**RE: Sealed Source Registration for MDS Nordion C-168**

Thank you for your e-mail of November 20, 2001, in which you requested additional information. Please find below the response to your questions.

**Figure A Serial Number 0001 Section, Polished (43x Magnification)**

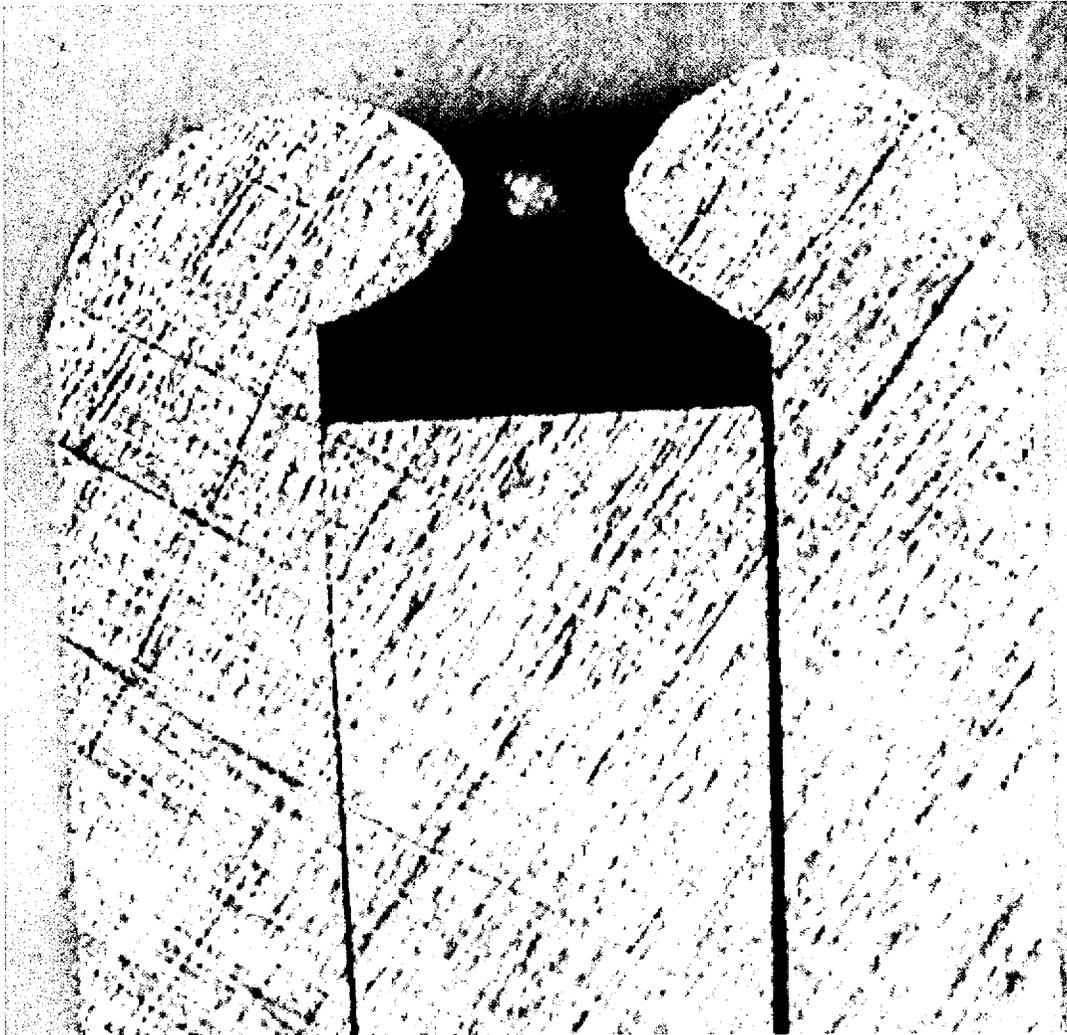
10. The Capsule Testing Work Sheet for the Vibration test, you reference an Appendix A concerning an extended length capsule which bubbled in leak testing. Please provide a copy of the Appendix A referenced by the work sheet.

Please find enclosed a copy of Appendix A.

An extended length capsule was used to ensure adequate free air space for the validity of the Helium Leak Test. The extended length capsule contains a pellet and a spring between the pellet and the plug. The spring has a diameter of 0.016". In one case, serial number 0001, the spring came off the pellet during handling and lodged beside the pellet allowing the plug to drop down. As a result, the welding was done without fusing the plug as seen in the polished section in Figure A below. This made it impossible to complete a vibration test on a second unit.

The spring is used to support the plug only for the longer capsule. During planning of the tests using an extended capsule length, it was proposed to use a spring to ensure sufficient free air space for helium leak testing, but a deficiency resulted from using the spring. The longer capsule with a spring is not used in production, but only for validation of the helium leak test. This fault could not happen in C168 production because a spring is not used.

**Figure 1 Serial Number 0007 Weld (76x Magnification)**

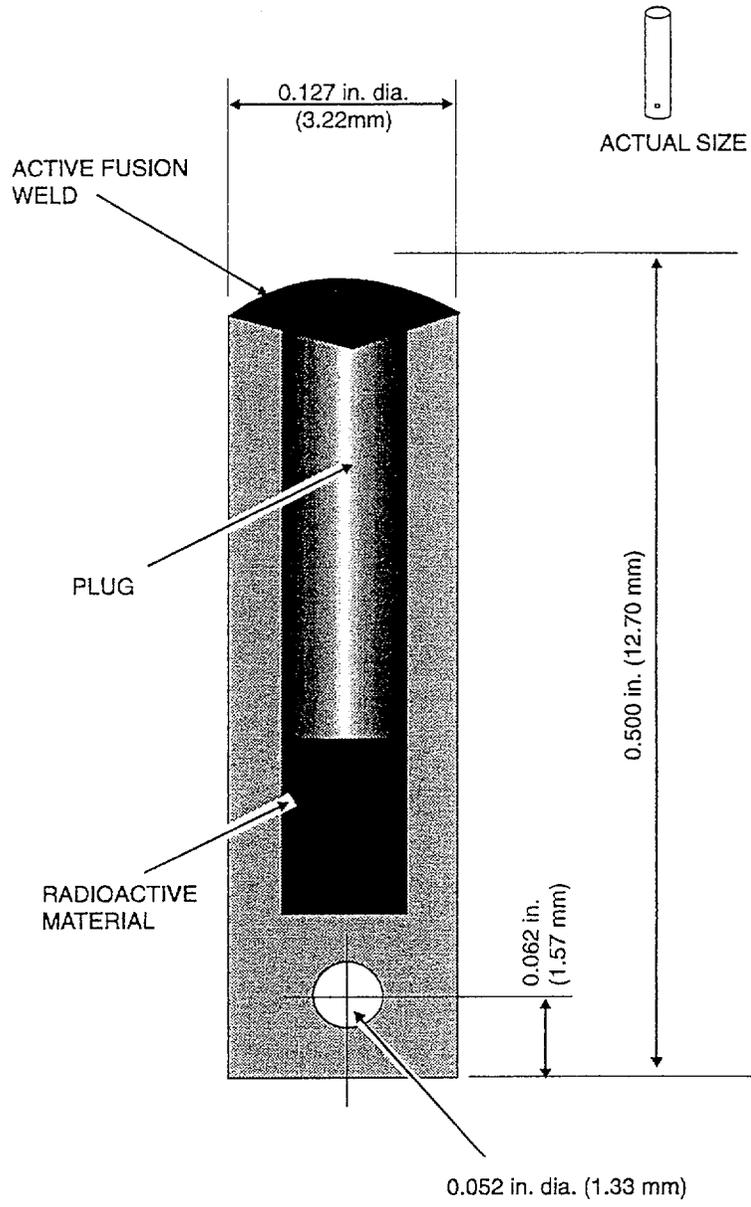
8. In the TESTING OF PROTOTYPES section, page 3, you state that one test capsule, number 0007, "had a degraded surface condition that resulted in an inconclusive helium leak test." Additionally, in the CAPSULE TESTING WORK SHEET for the temperature test, you stated that the helium leak test "results were inconclusive see appendix B." Please provide additional information on the degraded surface condition, specifically, what it was and why it prevented a successful helium leak test. Also, please provide a copy of the appendix B referenced by the work sheet.

Please find enclosed a copy of appendix B which explains the degraded surface condition.

During the temperature test the surface of the extended length capsule greatly degraded. As seen in Figure 1 below, the weld of serial number 0007 has a lot of scale and loose surface material. The rough surface condition resulted in helium becoming absorbed and trapped in the surface of the capsule. This surface condition resulted in inconclusive helium leak test results. The solid bar dummy also did not pass the leak test. As a result the Liquid Nitrogen-Alcohol Bubble test was used to qualify these capsules.

TITLE  
**C-168 Cobalt-60 Sealed Source**

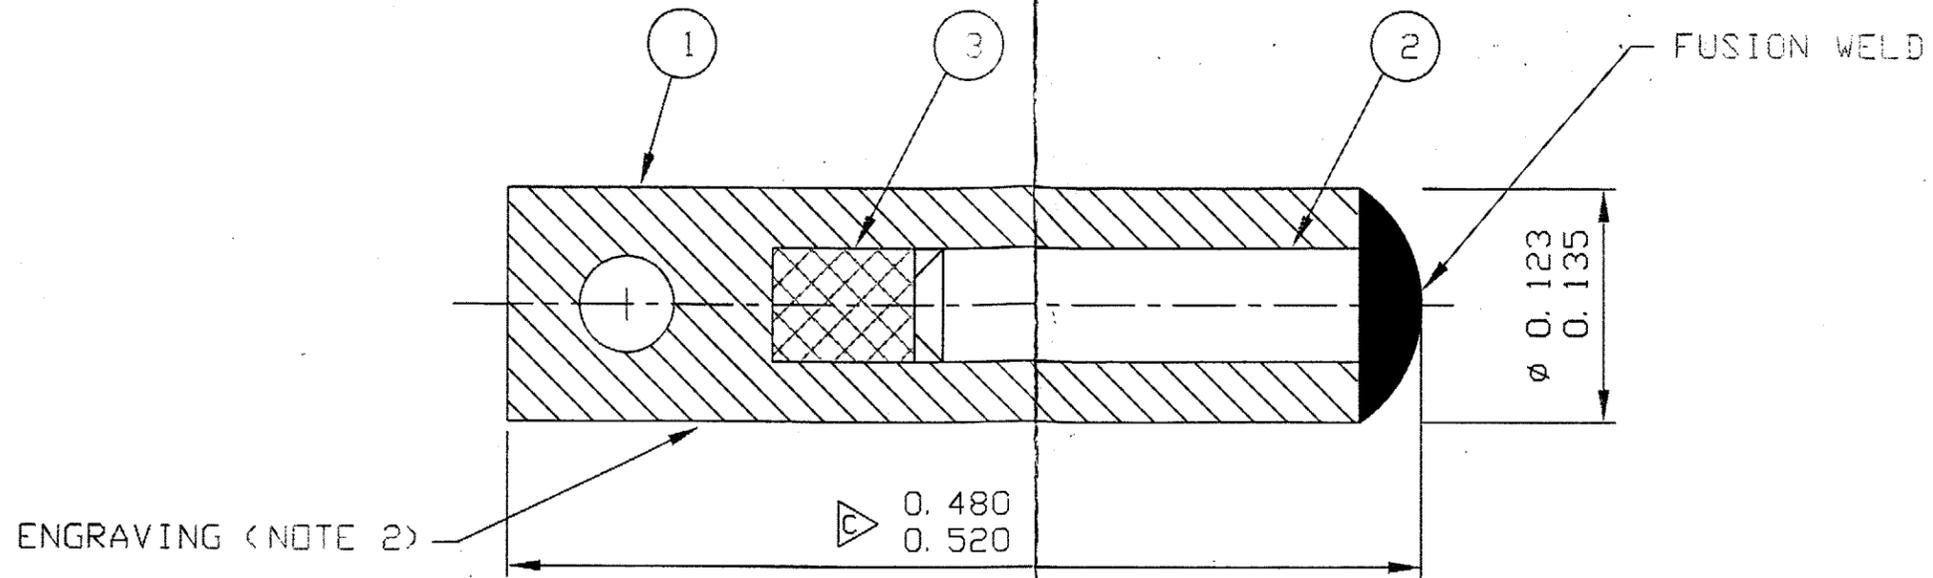
4. The drawing provided in Appendix A agrees with the LABELLING section on page 3 in that it states that either "NII" or "MDSN" is engraved on the capsule. However, the drawing provided in Appendix B only states that "NII" is engraved. Please explain the difference. Note that the Appendix B drawing is also used for the Canadian Special Form Radioactive Material Certificate shown in Appendix D.

Please see attached revised drawings G530102-141, Issue D and C-168, Issue 1, showing current engraving instructions, i.e. MDSN.

1. Conforms to IAEA Special Form requirements  
CNSC Certificate No. CDN/0015/S-85
2. Radioactive Material: Cobalt-60 in solid form
3. Material: Type 316L stainless steel
4. Engraved on capsule:  
RADIOACTIVE  
Co-60 C-168  
MDSN  
XXXX (Serial No. as specified)
